14 October 2022

Product Change Notice

Part Series Affected: AP Series Cosmetic Change

Example of AP830 and AP851:

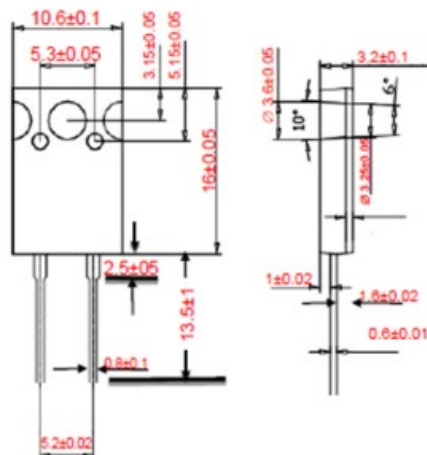
In response to the need for production expansion for select AP series resistors additional molding equipment is now in production. Parts made in the new equipment will have 2 small holes, 5.3mm apart, located below and to the left and right of the central mounting hole. The presence of these 2 small holes has no impact on form, fit, or functionality of the products. Both versions (with and without holes) will be used to fulfill orders.

Add 2 small round holes above**AP830 AP851**
